UNITED STATES PATENT AND TRADEMARK OFFICE

| APPLICATION NO. | FILING DATE | FIRST NAMED INVENTOR | ATTORNEY DOCKET NO. | CONFIRMATION NO. |
|-----------------|-------------|----------------------|---------------------|------------------|
| 09/661,705 | 09/14/2000 | Thomas J. Nelson | 068368.0131 | 8997 |

DETAILED ACTION

FIG. 1

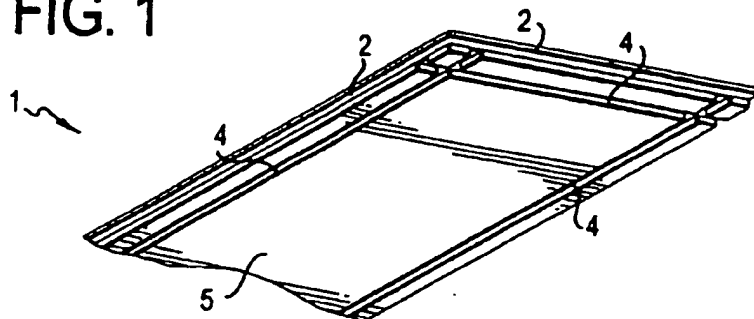
For claim 14, since the groove (4') of Martensson are in all four edges (2), it is clear that each groove does extend to and intersects with another groove of another side. For claims 16-18, note fig. 1. For claim 11, Martensson modified by Howorth, does not specify the thickness of the panel. However, the range of thickness specified in claim 11 is commercially well known. One of ordinary skill in the art would have make the panel of Martensson, modified by Howorth, in the thickness of the range between 0.24-0.32 inches to keep the cost down yet optimize the performance of the panel.

FIG. 2c

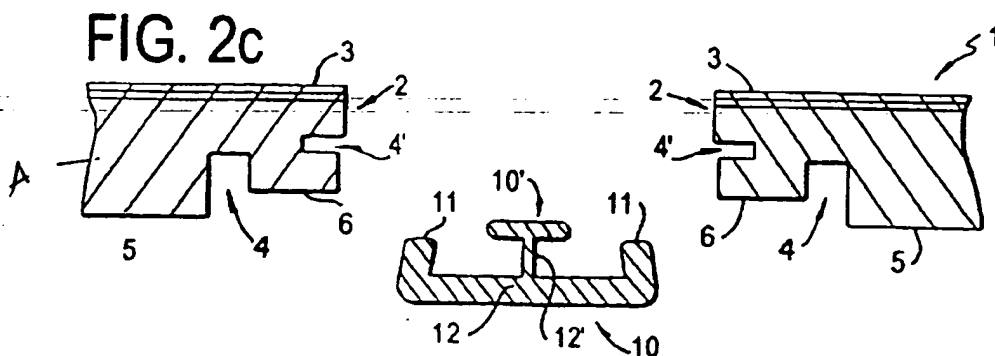
Martensson shows in fig. 2c adjacent flooring panels (1, 2) made of wood (lines 40-45, col. 6). Each panel has a top surface (3), a bottom surface (5) and a middle substrate (A). The middle substrate has identical grooves (4') formed along the edges and identical-profiled edges extending between top/bottom surfaces, and extend about the entire periphery of the flooring panel. See lines 20-22 of col. 7. Channel (4) formed within the bottom surface, associated and extending parallel with each edge.

Martensson does not show the channel having a top portion with outwardly tapering walls extending toward the bottom of the panel such that the channel becomes wider at the bottom of the panel than at the top portion of the panel. Martensson fails to show the channel includes a first wall defines an obtuse angle, and a second wall defines an obtuse angle, wherein the first and second walls extend in opposite directions. Howorth teaches providing a floor panel (24) with an outwardly tapering channel (35) formed within the bottom surface, associated and extending parallel with each edge. The

FIG. 2

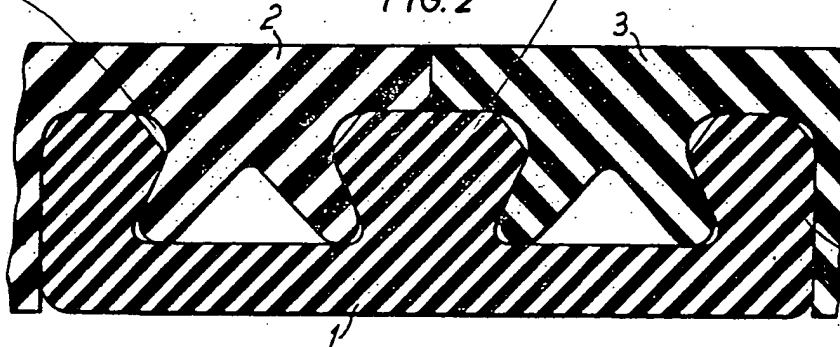
Hoffman et al: Fig. 2 shows a flooring panel (2 or 3) having a top surface, a bottom surface and a middle substrate. The middle substrate has identical grooves (A) formed thereon and identical-profiled edges extending between top/bottom surfaces and extend about the entire periphery of the flooring panel (see figs. 2 and 10). Outwardly tapering channel (B) formed within the bottom surface, associated and extending parallel with each edge. The channel has a top portion with outwardly tapering walls extending toward the bottom of the panel such that the channel becomes wider at the bottom of the panel than at the top portion of the panel. The channel includes a first wall (on the left of the channel) defines an obtuse angle, and a second wall (on the right

of the channel) defines an obtuse angle, wherein the first and second walls extend in opposite directions. Hoffman's panel is square but it can be in any configuration (lines 26-30, col. 4). The panel is made of rubber (lines 2-3, col. 1), which is equivalent of unfilled plastics and therefore encompasses the group of materials recited in claims 9 and 21.
